2018 RECHARGE MASTER PLAN

Prepared for:
Chino Basin Watermaster
Inland Empire Utilities Agency

Appendix C

Review Comments and Responses

Figure 1-3
Estimated Streambed Infiltration for the Santa Ana River Tributaries in the Chino Basin
and New Recharge Resulting from Recharge Master Plan Implementation, 1961 - 2017

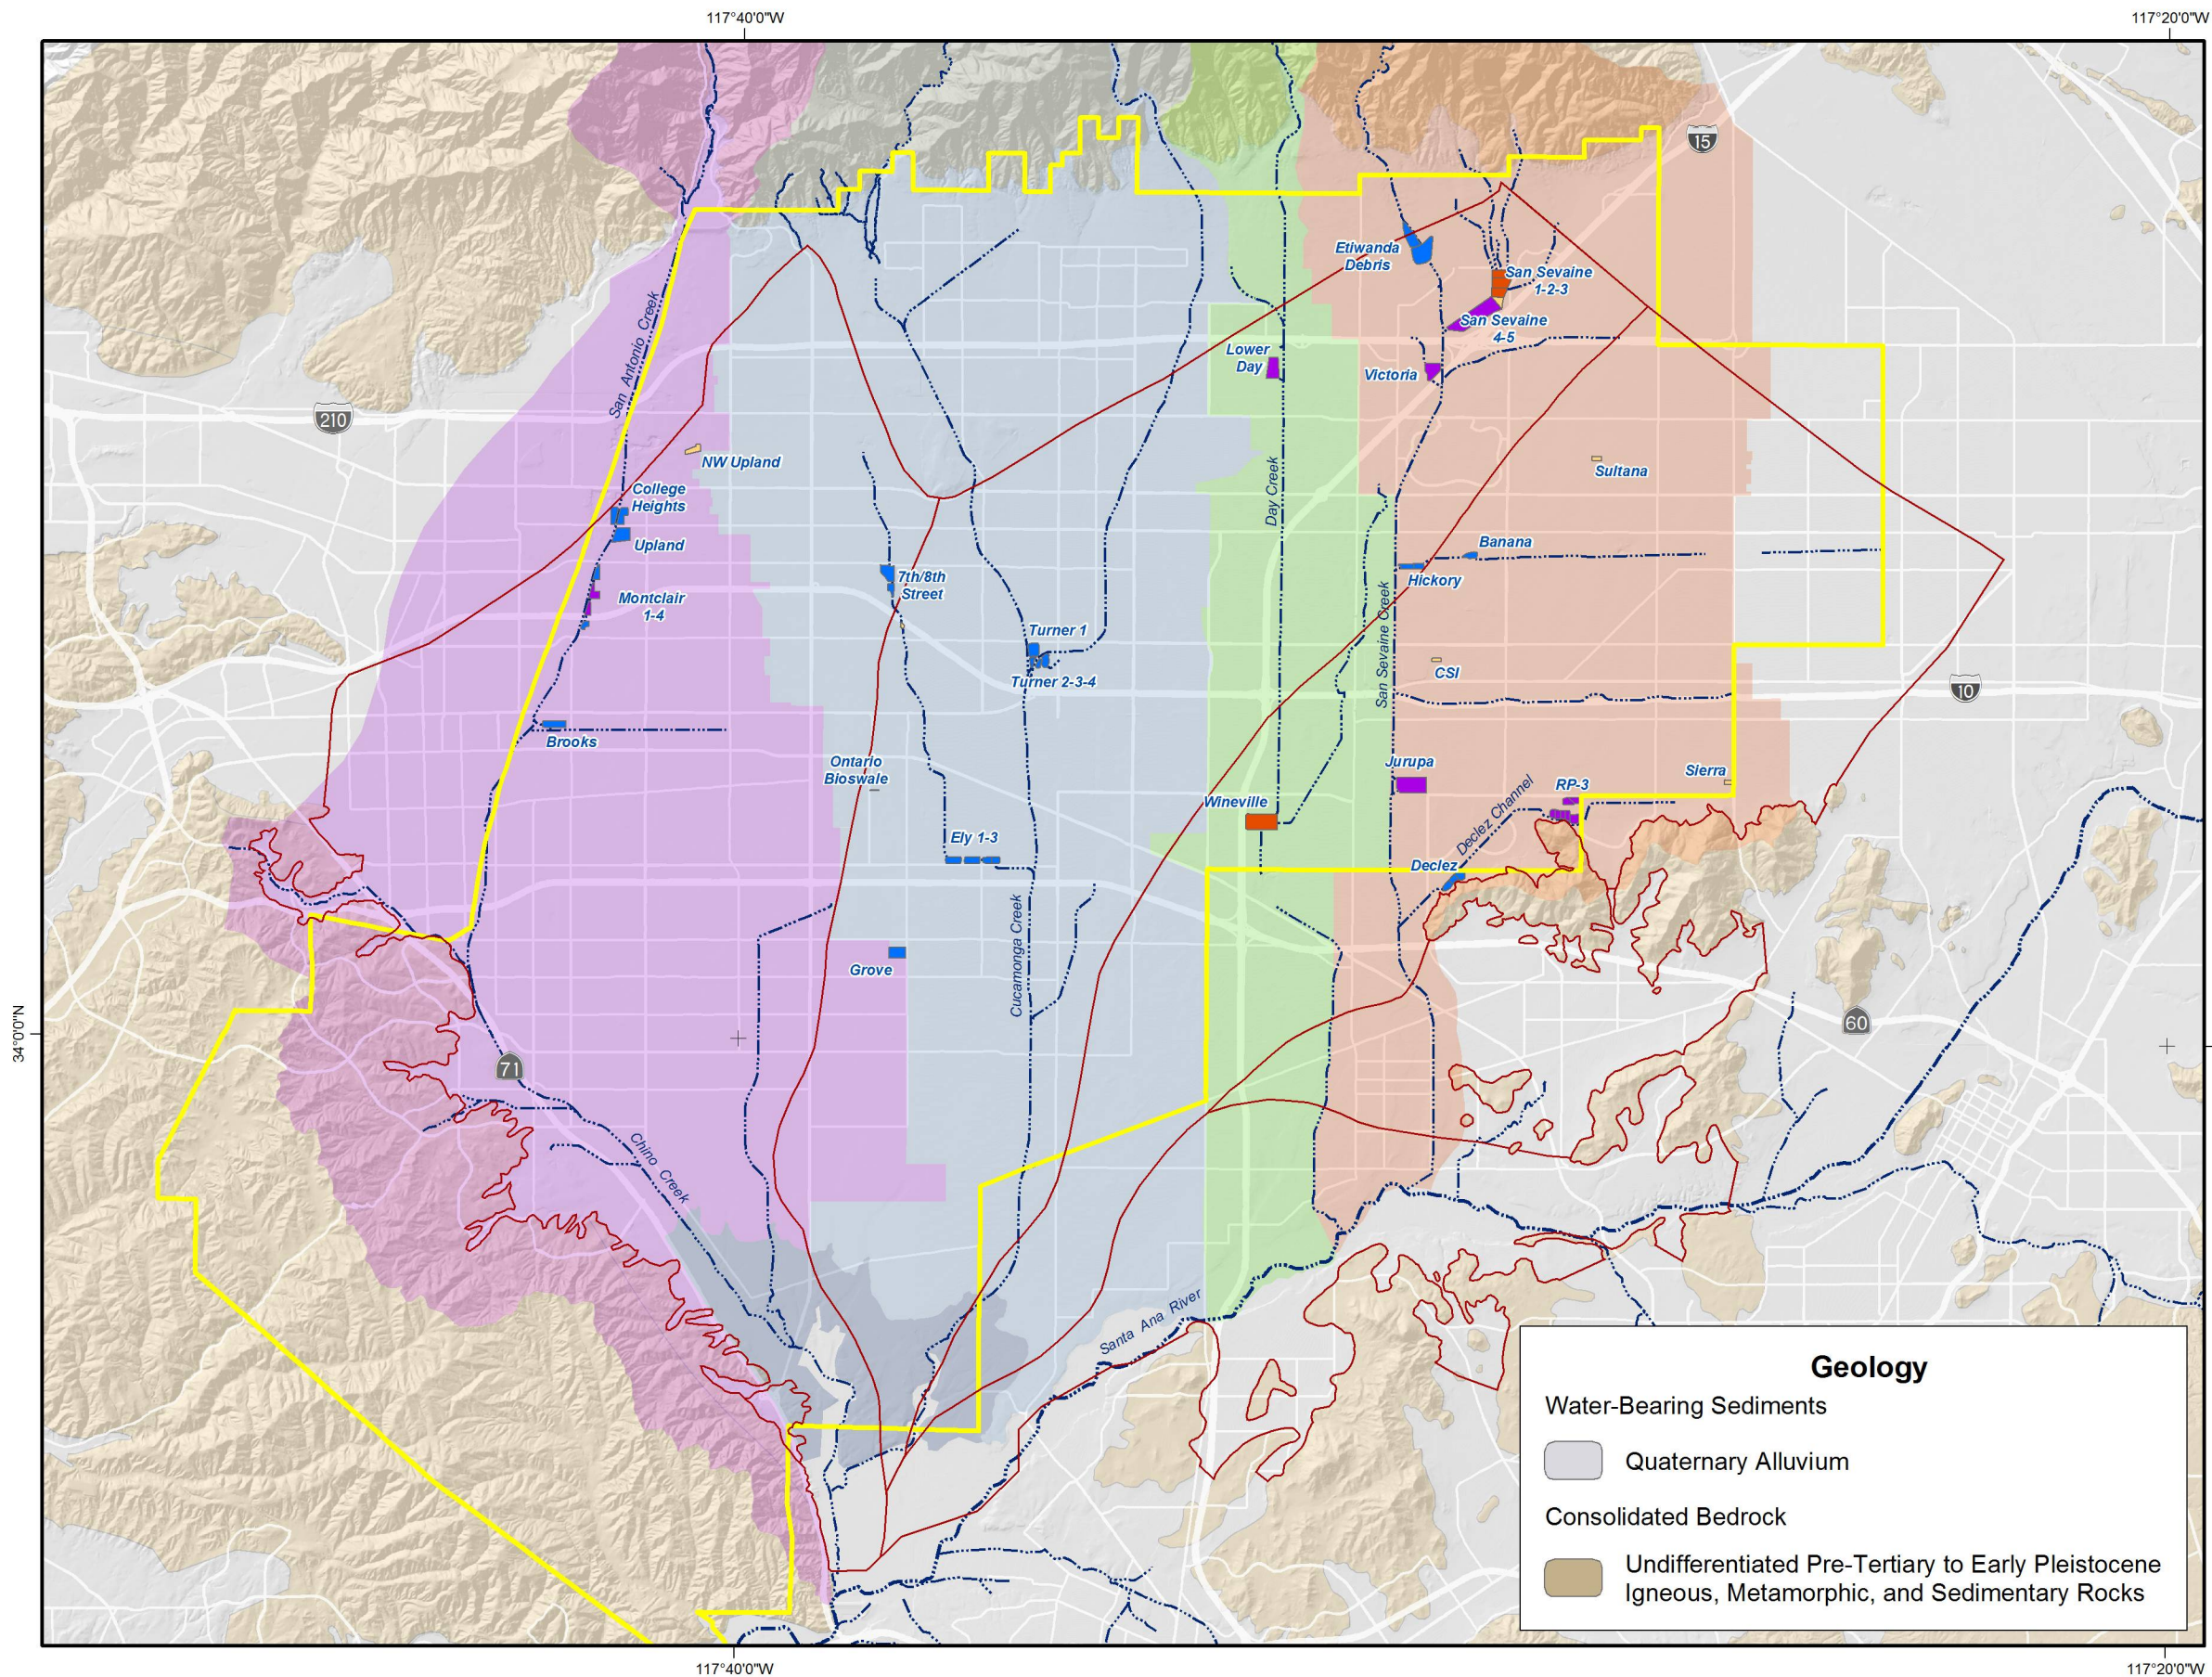
- 11. Figure 1-3: not sure what this really means - would like someone to explain it to me.**

Figure 2-3
Comparison of Aggregate Water Demand Projections in the OBMP (1999), Peace II (2007),
2013 RMPU and Safe Yield (2011), and Storage Framework/2018 RMPU

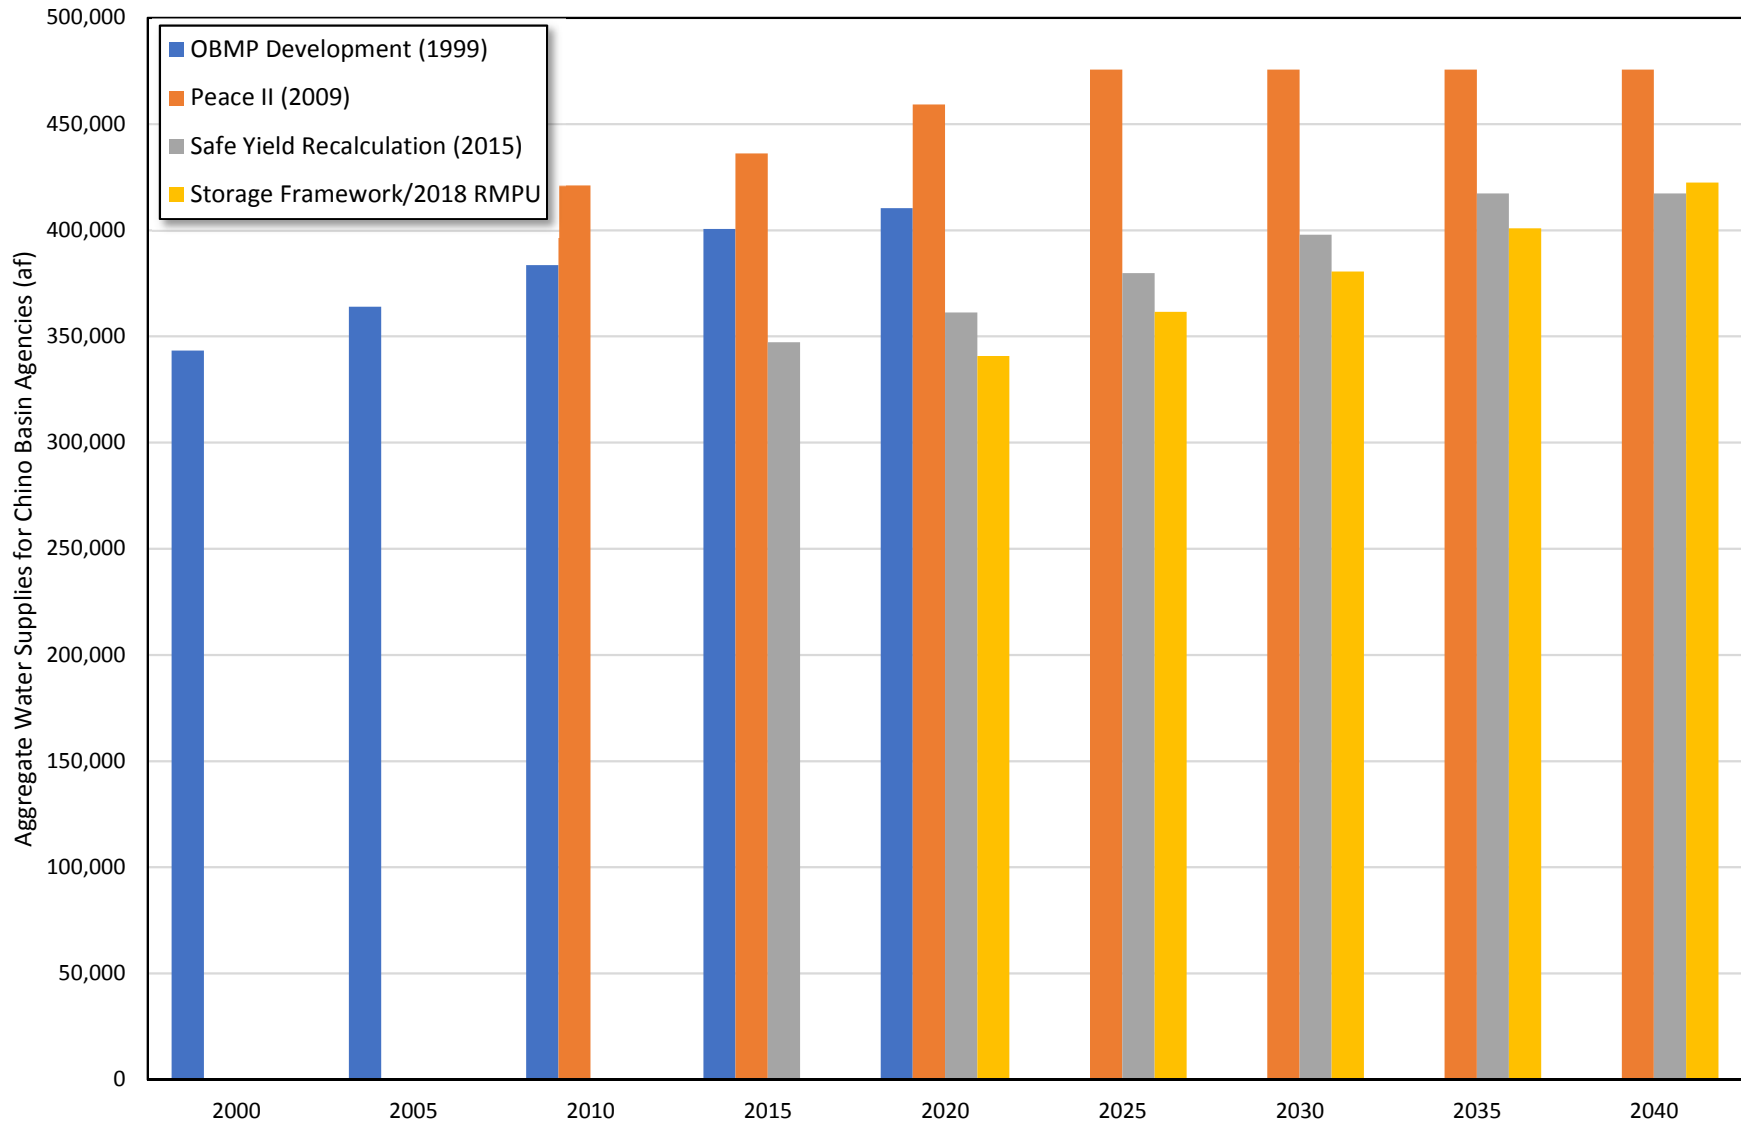
- 12. Figure 2-3: would like to see (perhaps not for this report), what actual water demand looks like plotted on this graphic - I think adding it would be a good reference for the report. If Wei doesn’t want to add, have them add it for us to see (outside of report).**

Figure 3-1
Historical and Projected Managed Storage, Scenario 1A

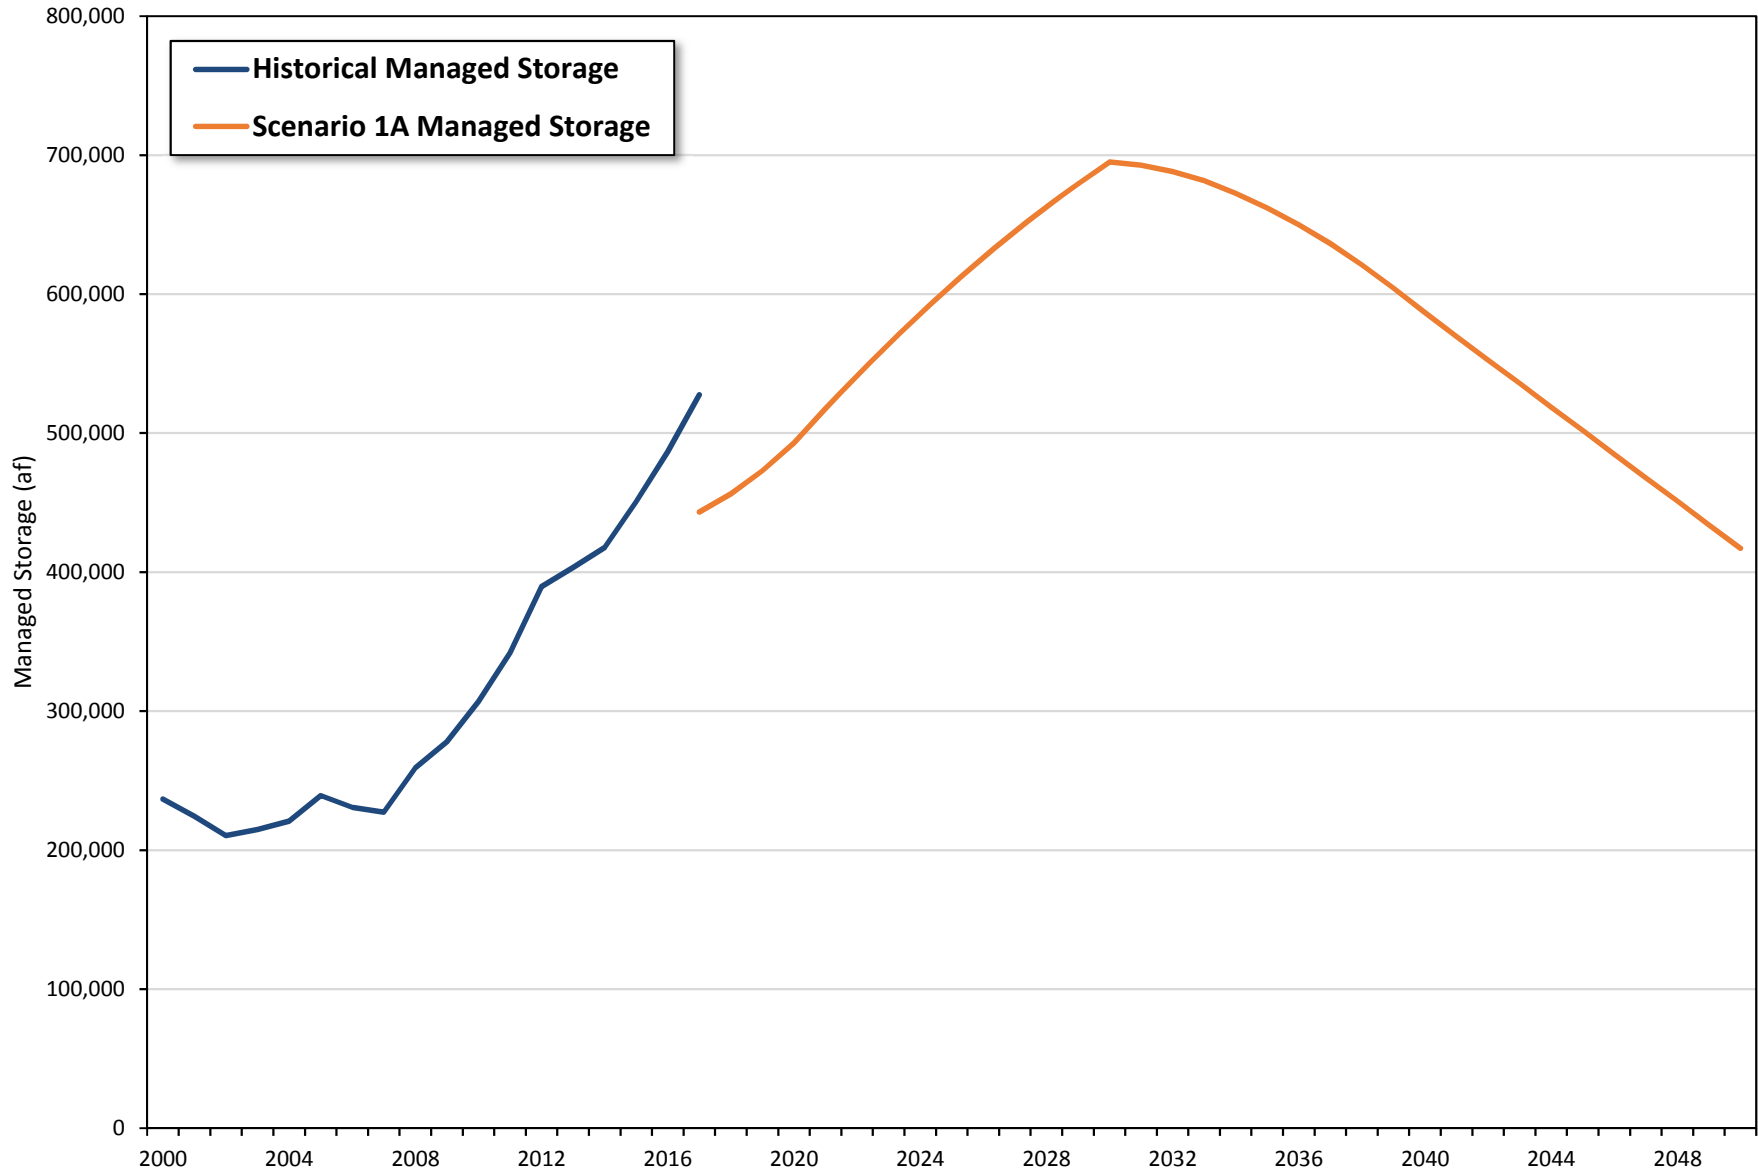
- 13. Figure 3-1: would like to better understand exactly what has driven the +300k AF increase in managed storage over the last 10-years.**
